## Audio Noise on Channels due to Improper Resistor population on Tribus / MADI Front Cards

### 1.0 Issue

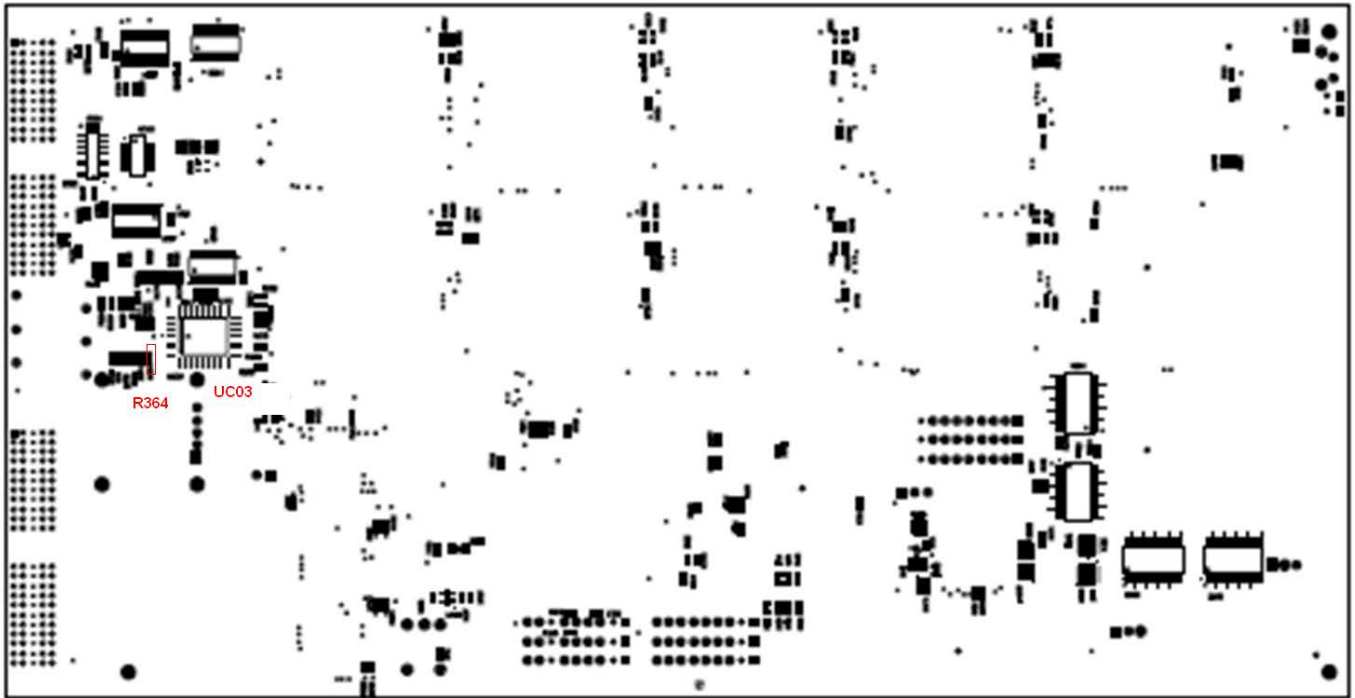
Field issues have been reported and confirmed in which timeslots in the ADAM matrix system have experienced noise due to the timing design of the Tribus & MADI Front Cards. A common Front Card is used for both the Tribus and MADI applications with the only difference being software programmed onto each card. It should be noted that this problem was originally discovered on the Tribus module prior to the production release of the MADI. The resistor should NEVER have been populated on the MADI Front Card builds. However, both engineering and tech support have verified a number of MADI Front Cards shipped new from the factory which have had this resistor populated in the field. As such, this issue should be inspected on these cards for any system where noise is present.

The circuitry in question is confined to the Tribus / MADI Front Card. No issues are present on the Tribus Back Card or MADI Back Card. The noise occurs on any AIO-16 card or other interface card that has small margins for the TDM bus set-up and hold time.

This issue typically shows up on the first port of a card but under worst-case conditions can affect every channel assigned to that card. For example: If an AIO-16 in Slot 2 is assigned to ports 17 – 32, the noise would typically be detected on port 17.

R364 (located on the back side of the Tribus / MAD1 Front Card) should be removed from all Front Cards. This is shown in the following assembly view:

The Engineering Changes which documented the removal of this resistor are EC# 46-002068 and EC# 46-002122.
